7 Acorn Street

Rear / Alley Balcony

BEACON HILL ARCHITECTURAL
COMMISSION APPLICATION

Revised Proposed Door to Balcony - Details

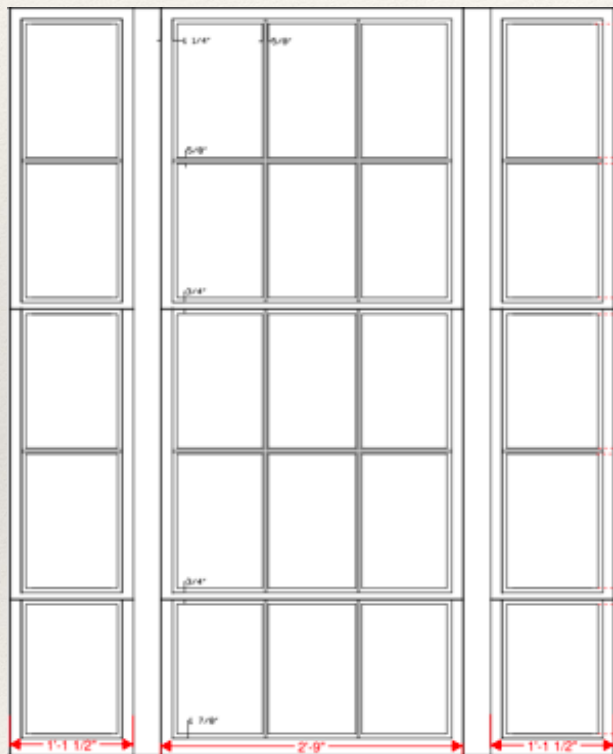
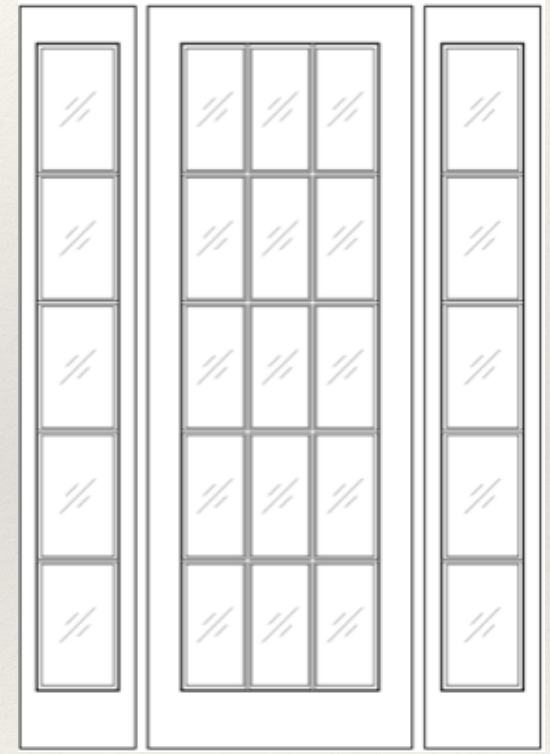
The sidelights will have a 7" bottom rail, 2" stiles, and a 4 1/2" top rail.

The door will have a 7" bottom rail, 4" stiles and a 4 1/2" top rail.

These are the minimum dimensions required for warranty

Revised Balcony Structure - Metal vs. Wood as Requested

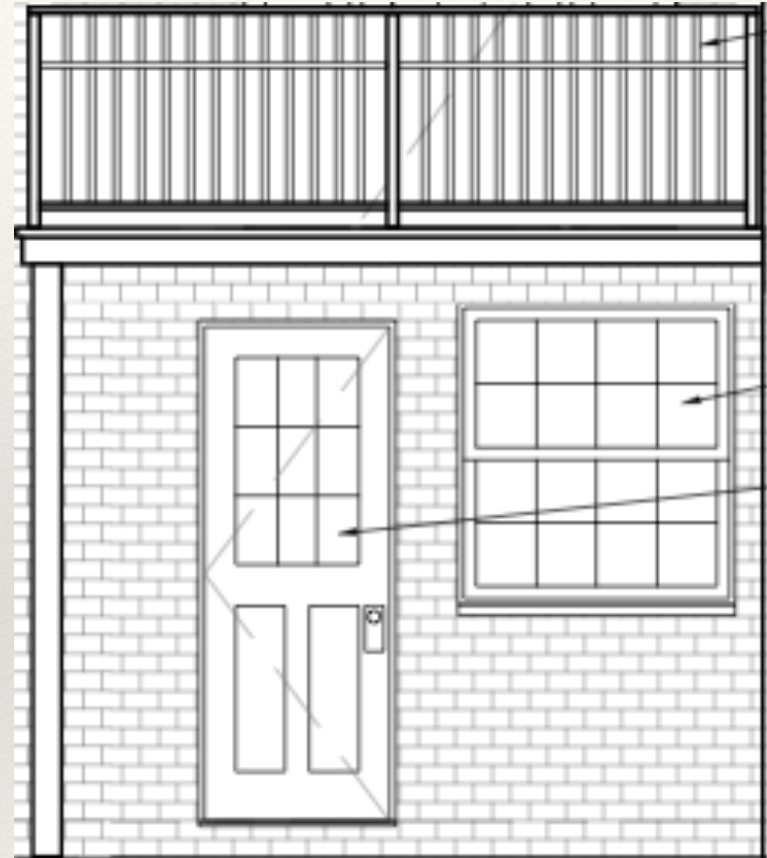
10" fascia has changed to 4" angle iron (painted black)
8" wood column has changed to 4" metal post (painted black)
